New Project Proposal: SFF-TA-1037

New Project Proposal: SFF-TA-1037 R1.0.1

- Purpose is to resolve issues found by review.
- Editor(s): Zhineng Fan
- Supporters
 1. Amphenol
 2. Lotes
 3. Micron

- **Figure 4-5 Contact Numbering**

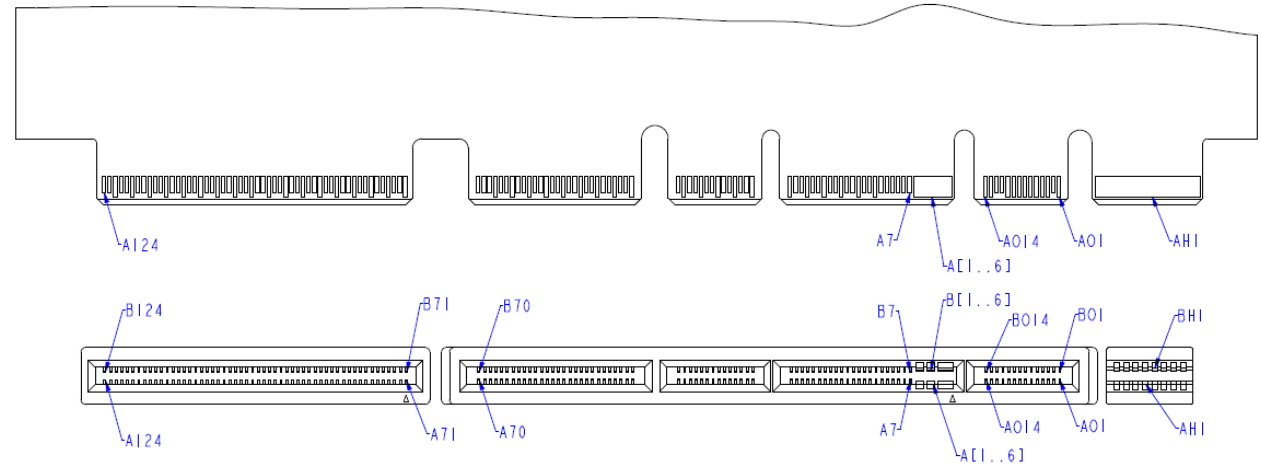
- Correct pin naming to be consistent with SFF-TA-1034
- Correct drawing errors and modify for manufacturability.
- Add connector type following SFF-TA-1002.
